Project	IEEE 802.16 Broadband Wireless Access Working Group < http://ieee802.org/16 >	
Title	Group TEK management for Multicast and Broadcast Service in IEEE 802.16e	
Date Submitted	2005-01-27	
Source(s)	[Rui Li] [Feng Tian] [Dongxin Lu] [zte] [ZTE Plaza , Keji Road South , Hi-tech Industrial Park , Nanshan District , Shenzhen , P.R.China , 518057]	Voice: [86-0755-26772016] Fax: [86-0755-26772004] [mailto:li.rui2@zte.com.cn]
	Prakash Iyer, Sanjay Bakshi Intel Corporation 2111NE 25th Ave, Hillsboro, OR, USA	Prakash.iyer@intel.com ; sanjay.bakshi@intel.com
Re:	802.16e/D5	
Abstract	This document contains new Group TEK management for Multicast and Broadcast Service	
Purpose	Adopt	
Notice	This document has been prepared to assist IEEE 802.16. It is offered as a basis for discussion and is not binding on the contributing individual(s) or organization(s). The material in this document is subject to change in form and content after further study. The contributor(s) reserve(s) the right to add, amend or withdraw material contained herein.

Group TEK management for Multicast and Broadcast Service in IEEE 802.16e

Figure 1 the model of MBS in MBS Zone

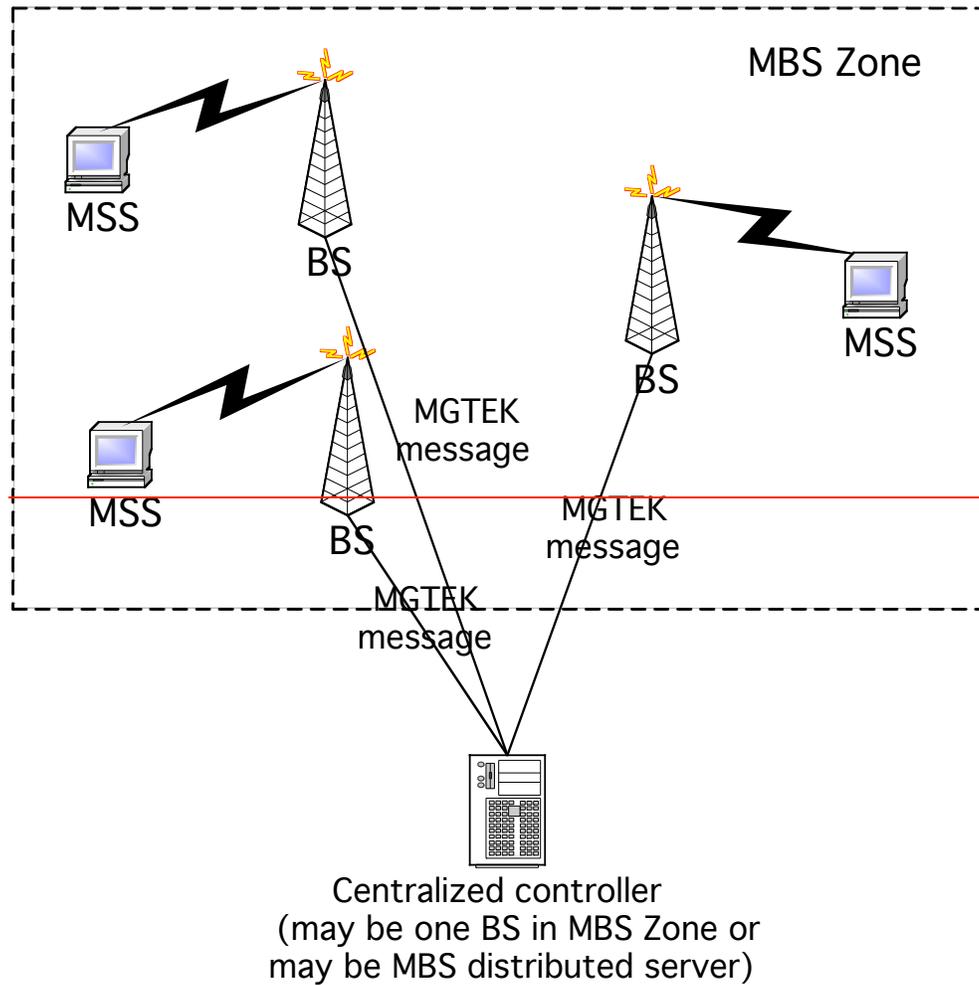
A new MGTEK management is proposed to realize that all BSs in MBS Zone synchronously manage MGTEK. The thought is that a centralized controller in MBS Zone is set to manage MGTEK. The centralized controller is used to manage MGTEK, such as the establishment of MGTEK, the distribution of MGTEK, the update of MGTEK and synchronization of MGTEK between all BSs. ~~The figure 1 illustrates the model of MBS in MBS Zone.~~
